**ADDENDUM NO. 3**

November 1, 2022

**RE: Component 5: Liquid Transloading Facility - Mechanical and Electrical Work at Facility One**

MIDWEST TERMINALS FACILITY 1 ELECTRICAL			
DATE	ADDRESS	TOWNSHIP	
10/24/2022	3518 ST. LAWRENCE DRIVE	OREGON	
DRN	CITY	COUNTY	SCALE
GMT	KEM	LUCAS	1"=20"
APVD	TITLE		
K. MILLER	<b>PARTIAL SITE PLAN: FOAM HOUSE AREA</b>		
ENGINEER'S STAMP	MT-101-3005

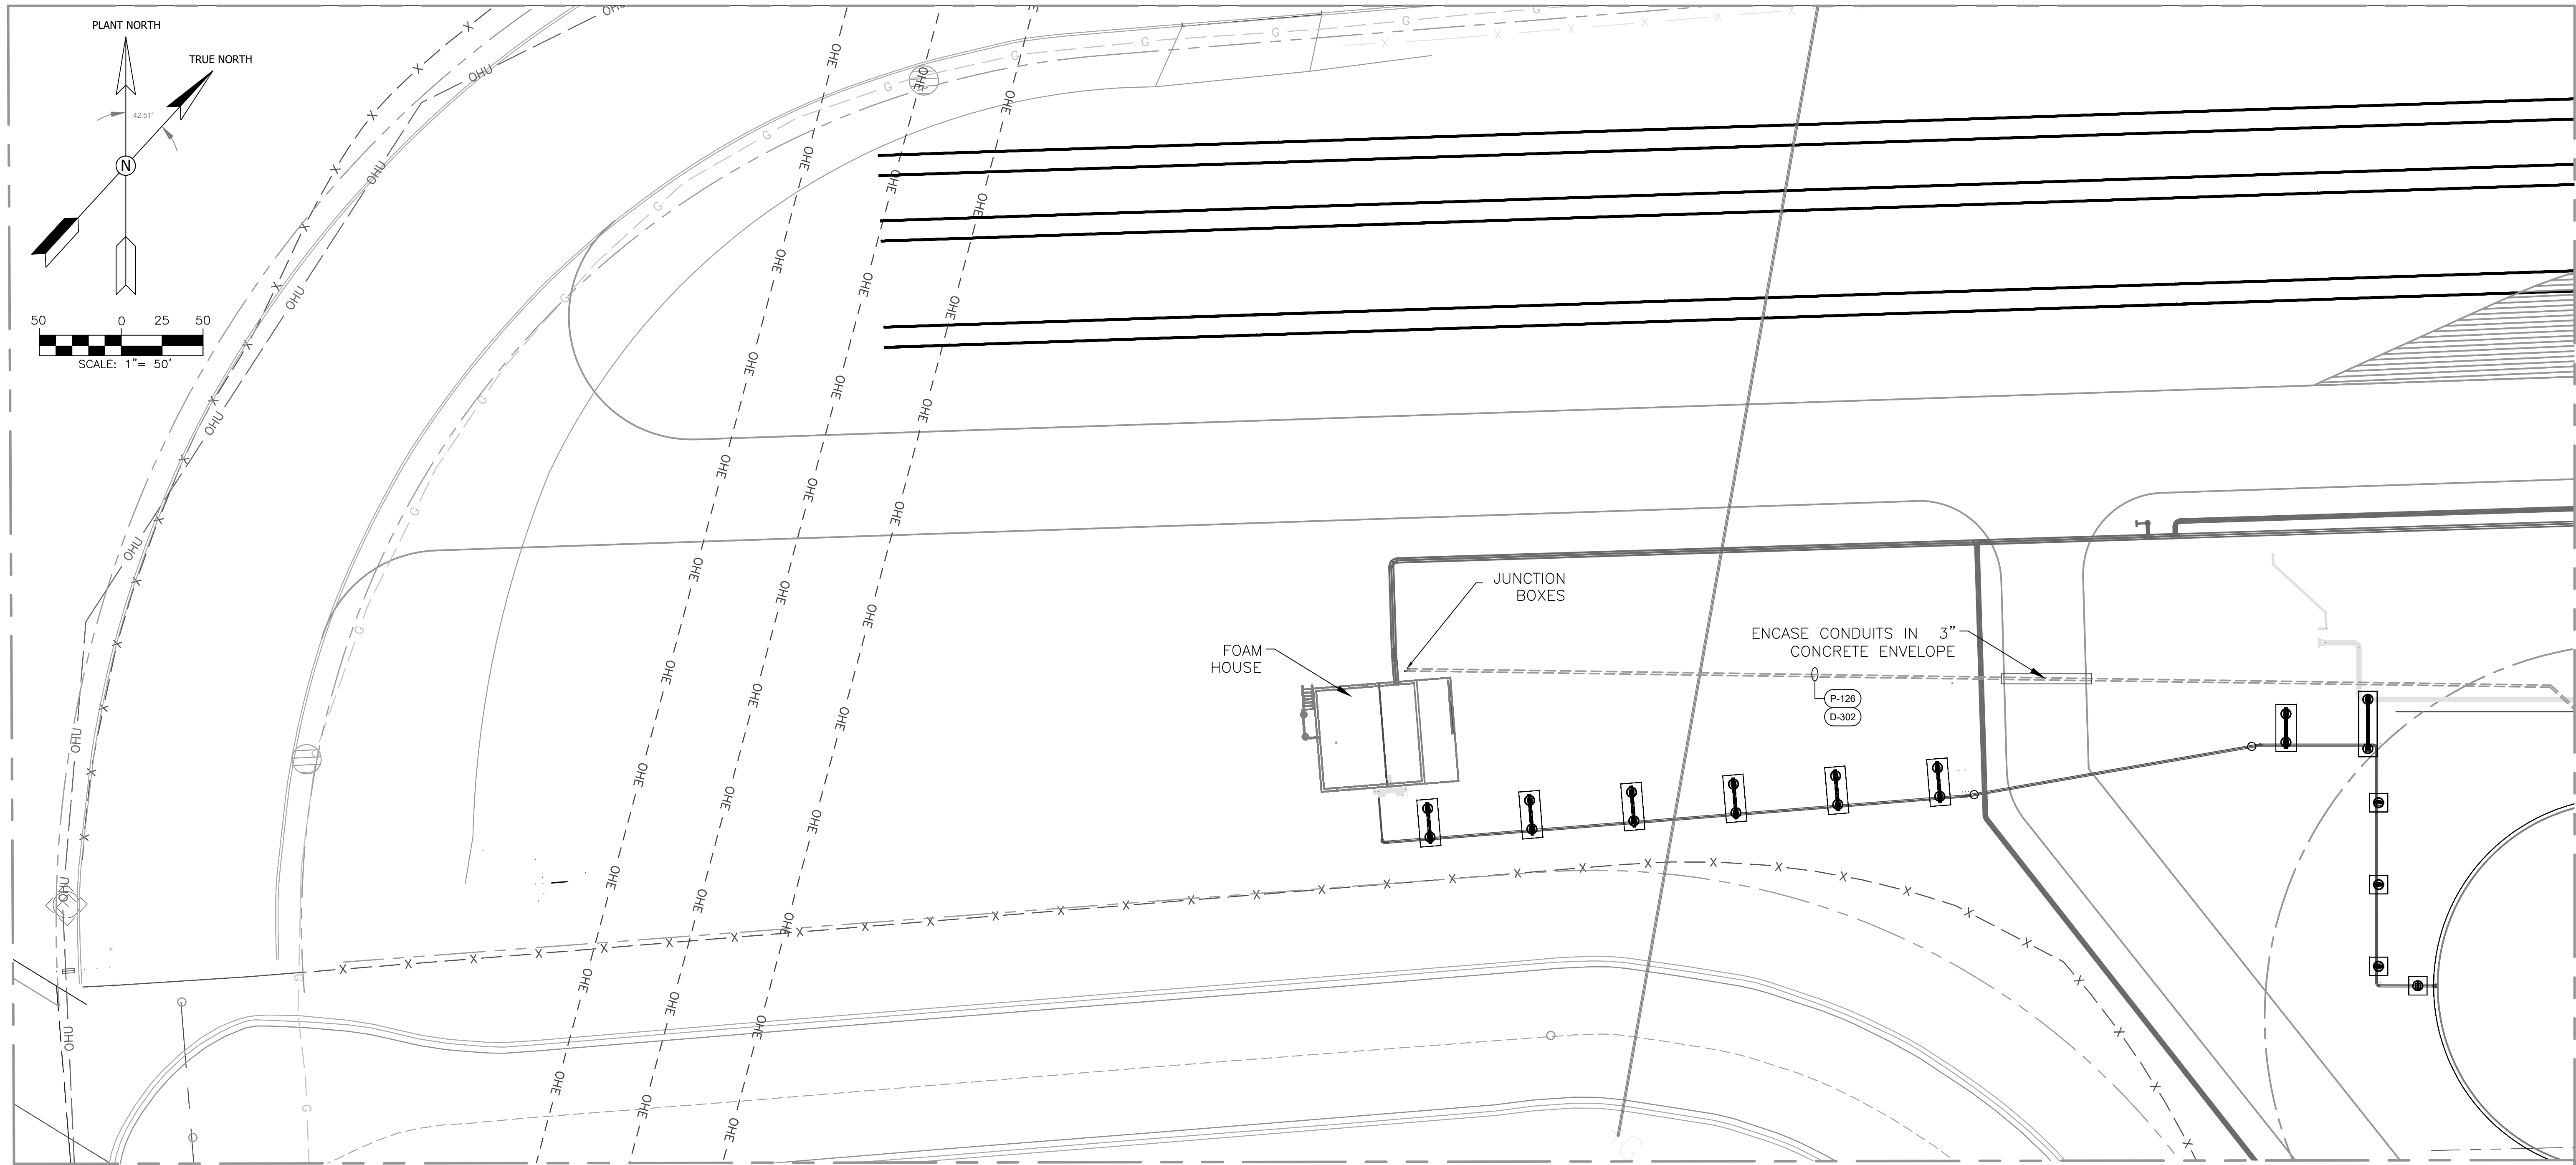
- The conference call line number for those that wish to hear the bids be publicly opened and read aloud is:  
Conference Call No.: (866) 252-0050  
Participant Code No.: 5156208#
2. Drawing MT-101-3005 (SEE ATTACHED)
    - Partial Site Plan: Foam House Area
  3. Project Scope – Mechanical & Electrical Work Package Revision 2 – (SEE ATTACHED)
    - Scope of Work Electrical - Exclusions from Scope
      - Item 3 removed

1. **Question:** Please clarify the scope of work between drawings for the Foam House on JDRM Drawing ED2 and MT-101-3005. Underground layout with J-boxes is different between the two drawings. Does the scope stop at the J-boxes?

**Answer:** Please utilize MT-101-3005 updated 10/24/22 for clarification of the underground conduit path from the cable tray to the Foam Building and disregard the routing on JDRM drawing E-2. There will be no J-boxes near the cable tray.

For specification of the J-boxes and installation from the boxes into the Foam Building, utilize JDRM E-2.

Please note that the power conduit should be a 3" (P-126) and the Communications Conduit should be 2" (D-302) and should be sized similarly from the J-boxes to the Foam Building.
